CITY OF DULUTH
PURCHASING DIVISION
Room 120 City Hall
411 West First Street
Duluth, Minnesota 55802-1199
218/730-5340
purchasing@duluthmn.gov

Addendum #1
Solicitation 19-0509
Western Waterfront Trail Wayfinding

COPYRIGHT 2016 BY LHB, INC. ALL RIGHTS RESERVED.
 PROJECT NAME
**WESTERN WATERFRONT
 TRAIL
 AMENITIES INSTALLATION**

EXHIBIT A

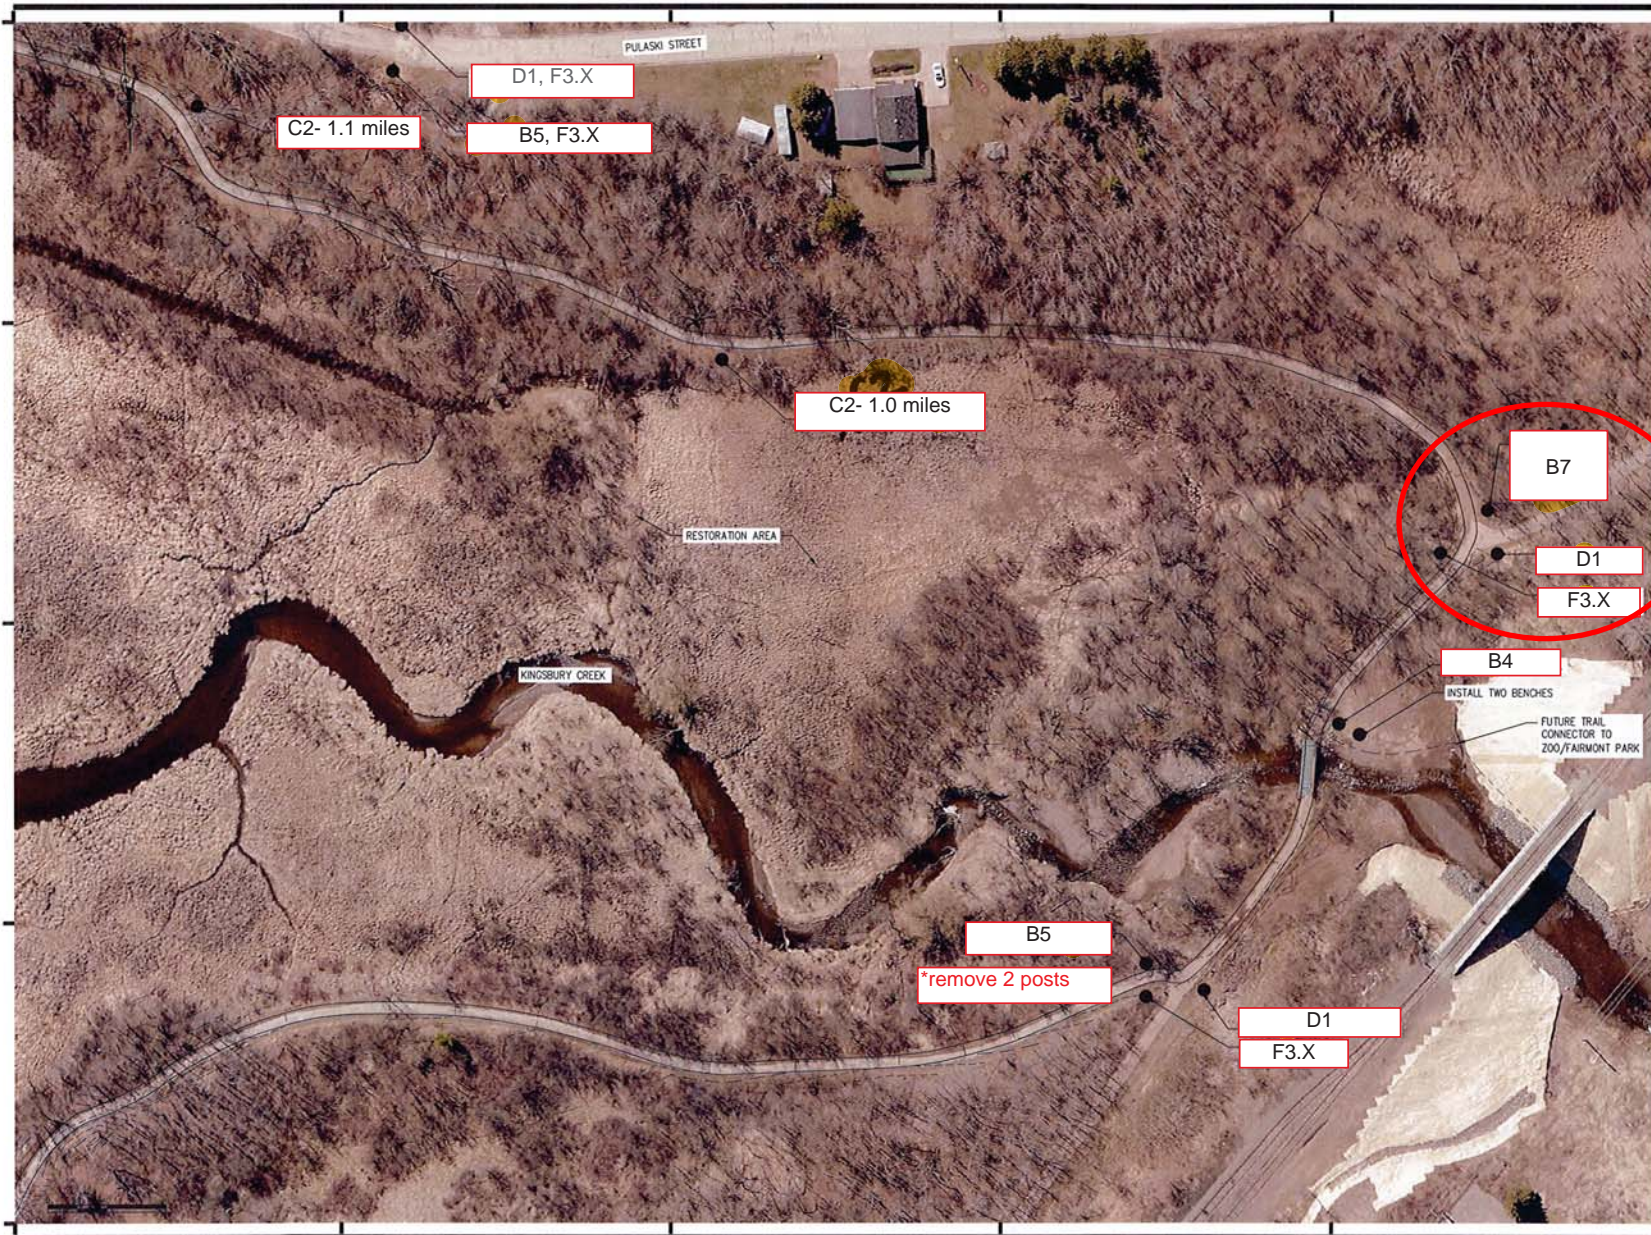
The awarded contractor MAY need to coordinate installation of the three signs circled in Exhibit A with Veit & Company, Inc., who will be working in the area under a Department of Natural Resources (DNR) contract. The timeline for the DNR's work is not yet finalized. Please bid the project with complete installation. Any changes that may be required, once known, will be addressed via a contract change order.
